September 19, 2016

Re: Bicycling Connectivity Improvements - Stanley Park Causeway South End

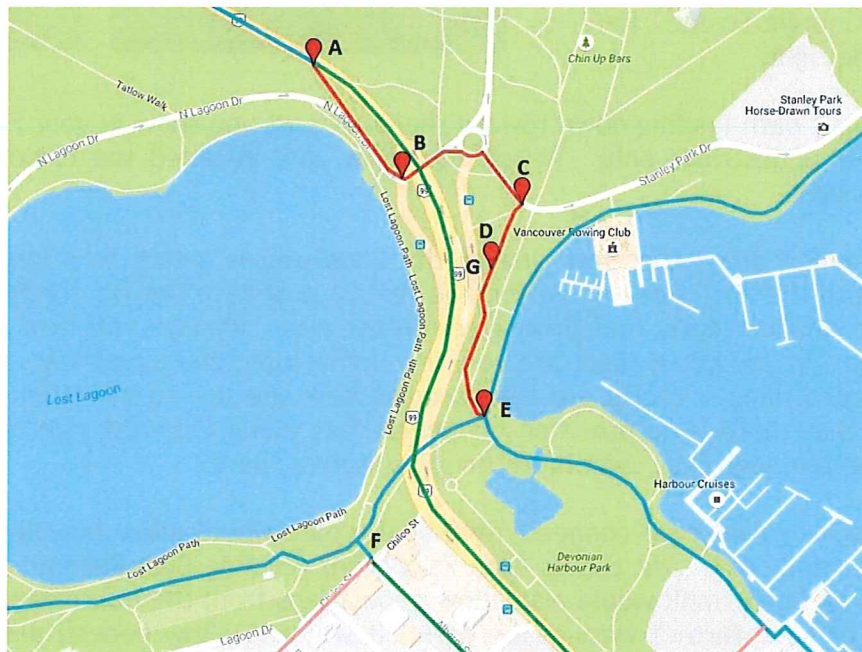
The first issue you raised is the south end of the Causeway sidewalk, in particular concerns around the safety of the unprotected painted bike lane on the S-Curves. You noted a lack of time at the decision point where the sidewalk transitions into the painted bike lane.

When the Causeway was upgraded in 2000, the design was for all cyclists to continue along the S-Curves and either remain on Georgia Street or enter Stanley Park at the Chilco Street bicycle entrance from Georgia Street. Refer to the photos to the right.

The narrow asphalt path leading down toward the underpass you show in your Figures 6 and 7 was intended for pedestrians only. We do not know who installed the existing green sign above the ramp signs.

The design proposal to improve connectivity into the park would allow bicycles to enter the park before the ramp with safe access onto Park Drive (Cycling Plan Recommendations 8b). The curb ramps and crosswalk would also allow pedestrians from the Causeway to head down to Lost Lagoon or head further west in the park. It will also allow pedestrians coming from Tatlow Trail wishing to head to the east side of the park via the underpass rather than heading down to Lost Lagoon to do so. Appropriate signage would be installed as part of the implementation. This connection will also facilitate Cycling Plan Recommendation 13c and/or 14b if two-way traffic is introduced onto North Lagoon Drive in the future, subject to a traffic study to determine feasibility and network impacts.

Assuming bicycles will be on the road, appropriate signage and markings will have to be designed. These could be Sharrows on the roadway.

There was a red box that Engineering installed some years ago that has been removed. If HUB may want it replaced with a green box, we would have to discuss that in light of challenging sight lines at that intersection.

We agree that a curb cut is needed here with appropriate wayfinding and shared path signage to allow the designation of this pathway to be a shared path between Points C and E. This also facilitates Cycling Plan Recommendations 1b and 1c to allow bikes to return to downtown from attractions along the Seawall and in the park.

The path between Points C and E are indicated as being two-way. There is a pedestrian path to the east between Point E and the underpass that is heavily used by cyclists heading towards the Causeway. We suggest that this pathway, due to it being so narrow, be marked as a shared path with one-way north only for cyclists. Refer to the photo to the right.
